April 21, 2011

**Subject: Bull Hill Wind Project: DP 4886: Application Amendment: Vernal Pool Redesign**

PERMIT  
**C-602**

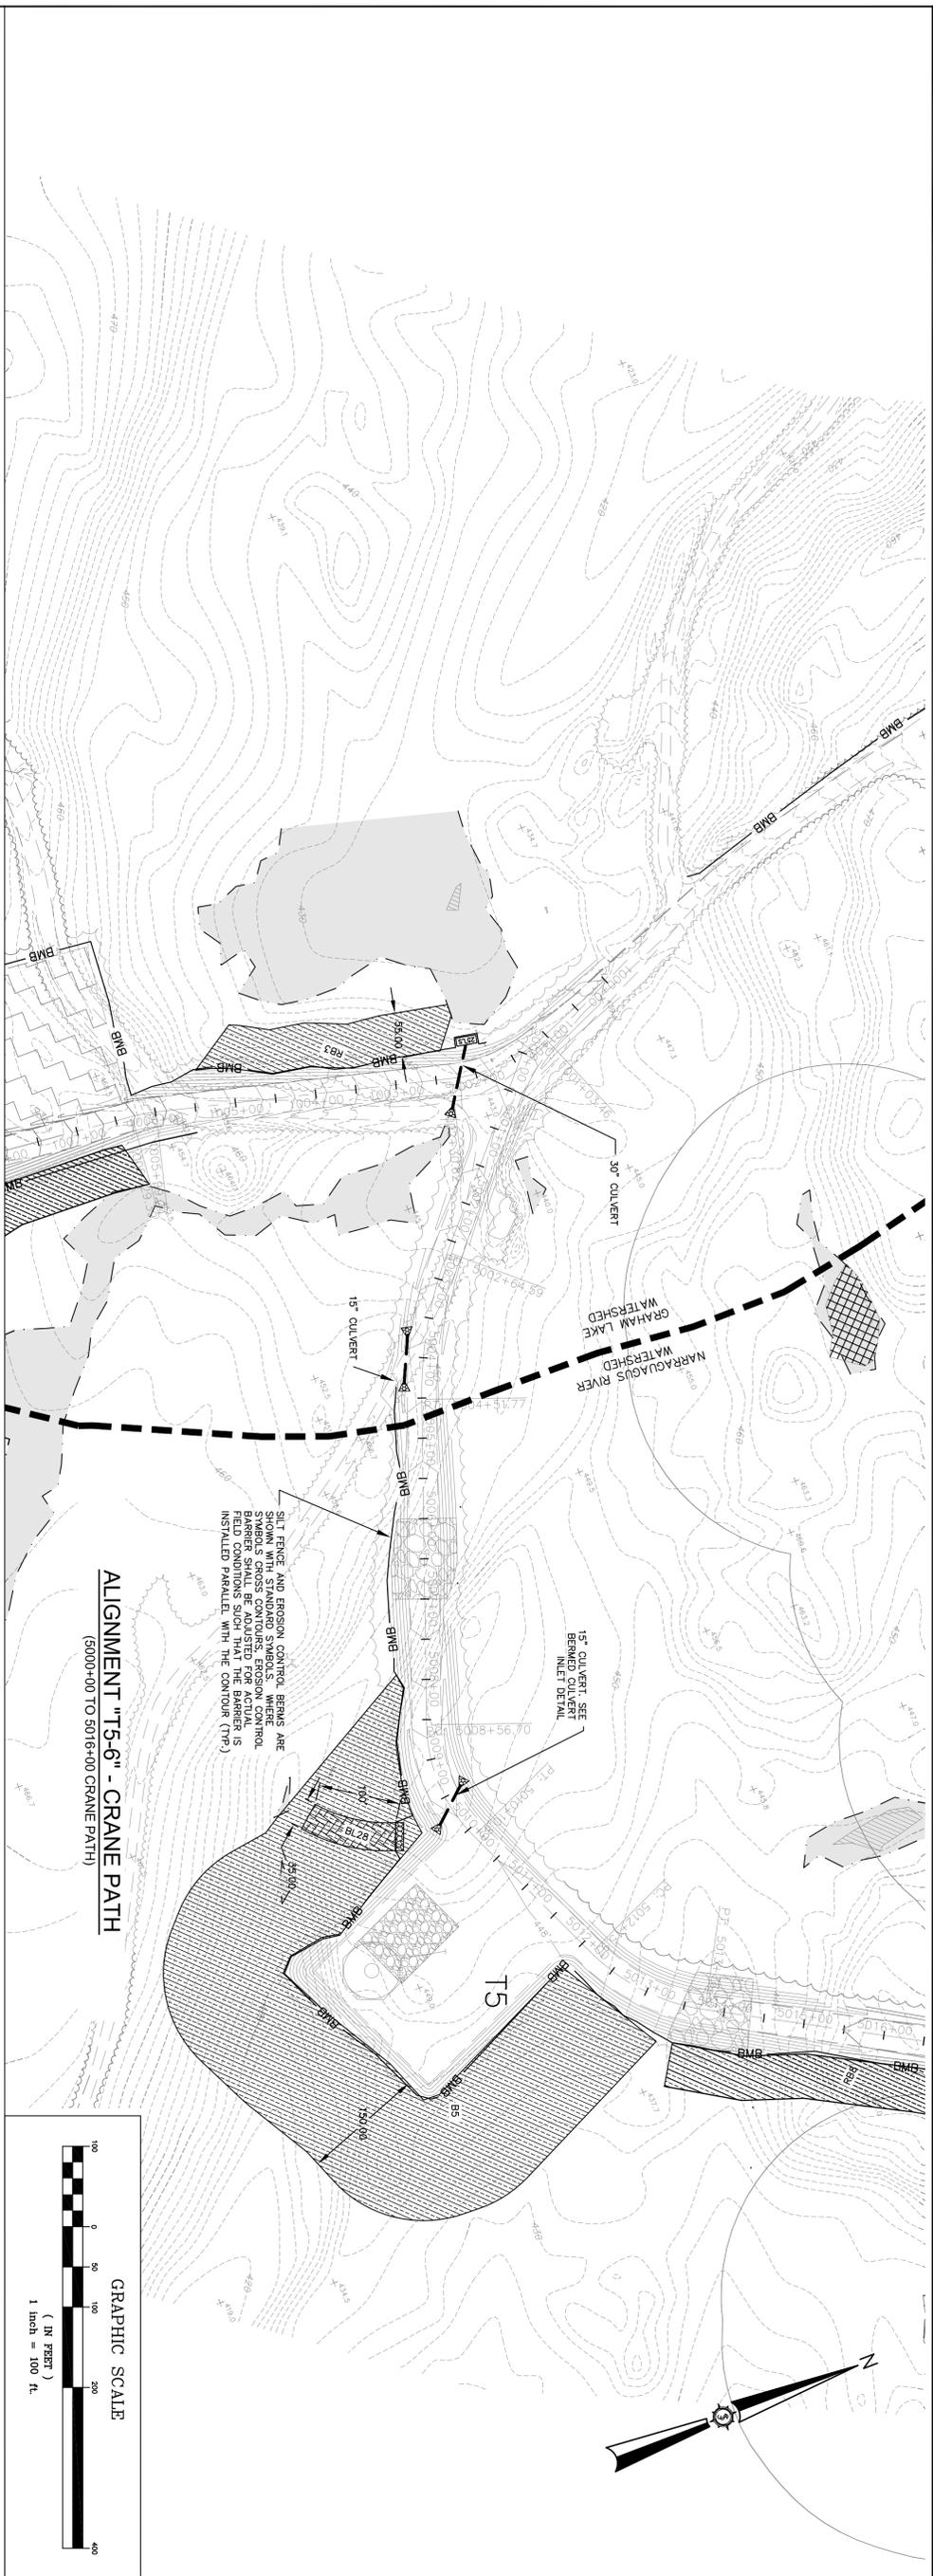
Rev. #	Drawn By	Description	Date
1	MT	REVISED PER LURC COMMENTS DATED 01/18/11	1/25/11
2	JLD	REVISED PER AGENCY COMMENTS DATED 04/11/11	4/15/11
3	JLD	REVISED T5-6 CRANE PATH TO AVOID SVP BUFFER	4/21/11
